Discrete/UMA Schematics Document

Sandy Bridge

Intel PCH

QUEEN 15

Title			
DDR3-SODIMM2			
Size Custom	Document Number		Rev
	QUEEN 15		A00
Date:	Tuesday, January 04, 2011	Sheet 14 of	108

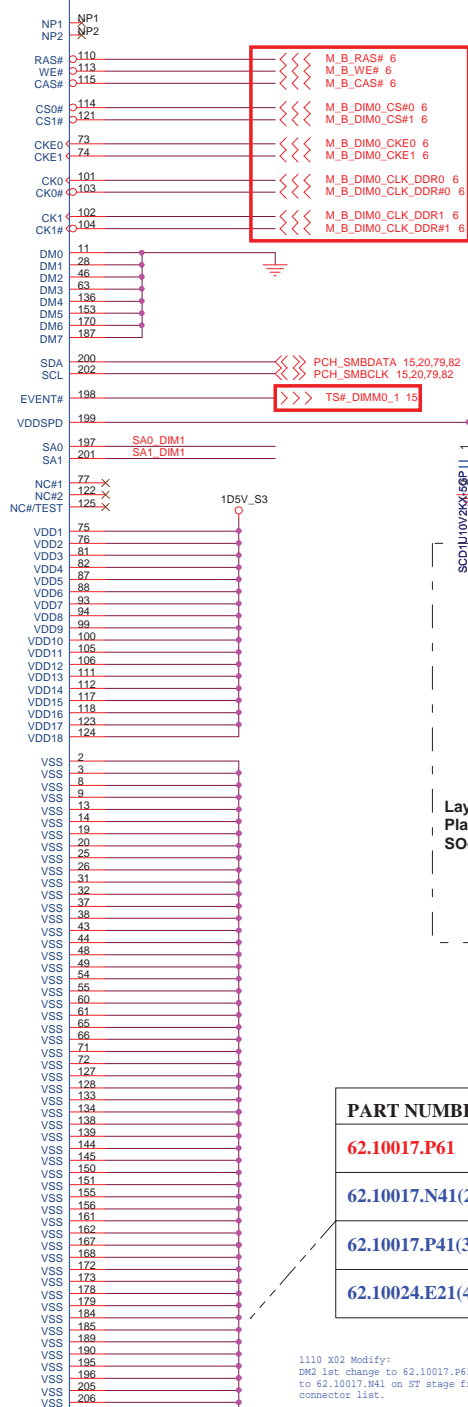
1110 X02 Modify:
DW2 1st change to 62.10017.P61; 2nd change
to 62.10017.N41 on ST stage from ME updated
connector list.
